MILITARY SPECIFICATION

CRATES, SLOTTED ANGLE, STEEL OR ALUMINUM, FOR LIGHTWEIGHT AIRFRAME COMPONENTS AND BULKY ITEM (FOR MAXIMUM LOADS OF 3000 POUNDS)

This amendment forms a part of Military Specification MIL-C-9897B, dated 23 July 1974, and is approved for use by all Departments and Agencies of the Department of Defense.

FIGURE 17

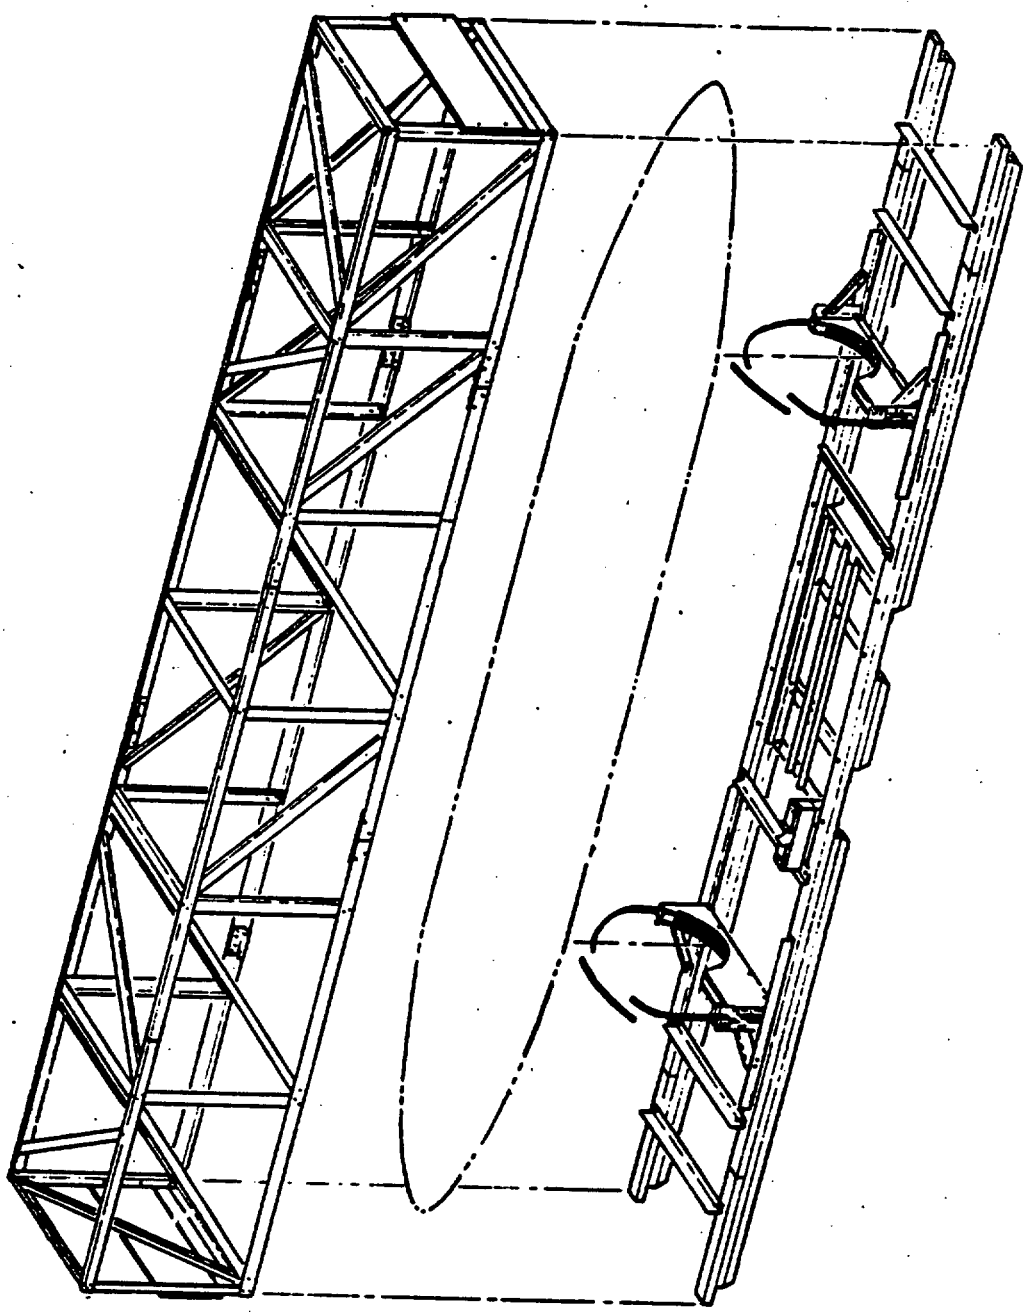
3.3.3: Delete fourth sentence and substitute, "Flooring shall be cut to fit in place and should be bolted to the lower side rails of the crate, except when crates are constructed in accordance with Figure 17."

3.8, line 4: Change "shock and vibration isolation systems," to read "shock and vibration isolation systems, removable superstructures (see Fig. 17),".

Following page 38: Insert new page 39, Figure 17.
